Access Compliance Report

Public Rights-of-Way

(Curb Ramps)

Intersection ID: 48452	Main Street: RED_RUST_LN	Cross Street: BURNT_LEATHER_LN	Location: NE
ADA ID: 1BD0E685FC65	Ramp Type: BlendTrans1	Initial Pass/Fail: Fail	Overall Compliance: No
		Severity Score: 10

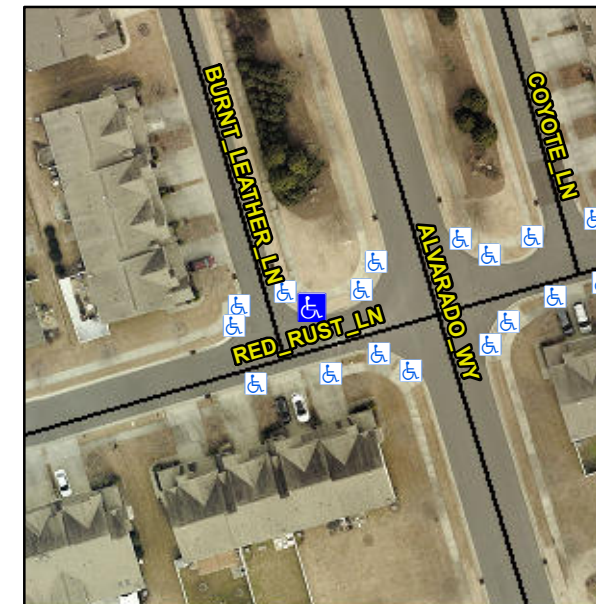
Not Found, R304.5.1, R304.5.3

Compliance	Description	Data	Compliance	Description	Data
N/A	Ramp Length (in)	72.0	Yes	BlendTrans Slope (%)	4.2
No	Ramp Width (in)	46.0	No	BlendTrans XSlope (%)	2.7
N/A	Flare Type LT	N/A	N/A	Flare Type RT	N/A
N/A	Flare Slope LT (%)	N/A	N/A	Flare Slope RT (%)	N/A
N/A	Flare Traversable LT?	N/A	N/A	Flare Traversable RT?	N/A
N/A	Landing Length (in)	N/A	N/A	DWS Provided?	N/A
N/A	Landing Width (in)	N/A	N/A	DWS Contrast?	N/A
N/A	Landing Slope (%)	N/A	N/A	DWS Length (in)	N/A
N/A	Landing X Slope (%)	N/A	N/A	DWS Full Width?	N/A
N/A	Landing Curb? (Y/N)	N/A	N/A	DWS Offset (in)	N/A
N/A	Shared Landing?	N/A			
N/A	Gutter Ponding?	N/A	N/A	Gutter Slope (%)	N/A
N/A	Gutter Lip Ht (in)	N/A	N/A	Gutter X Slope (%)	N/A
N/A	Painted X Walk1?	No	N/A	Painted X Walk2?	N/A
	X Walk 1 Direction	To SE		X Walk 2 Direction	N/A
	X Walk 1 Width (in)	N/A		X Walk 2 Width (in)	N/A
	X Walk 1 Slope (%)	0.6		X Walk 2 Slope (%)	N/A
	X Walk 1 X Slope (%)	1.9		X Walk 2 X Slope (%)	N/A

N/A	Ramp inside XWalk1?	N/A	N/A	Ramp inside XWalk2?	N/A
	Road Slope (%)	1.9		Clear Space?	N/A
	Road X Slope (%)	0.6	N/A	Clear Space to XWalk (in)	N/A
N/A	Any Obstructions?	N/A	N/A	Storm Grate/Utility Hazard?	N/A
	Obstruction Type			Storm Grate/Utility Type	
		N/A			N/A
			Yes	Surface Condition? (G/P)	Good
			No	Curb Slope (%)	11.1

Remove & Replace Curb Ramp With Two New Directional Ramps or Equivalent.
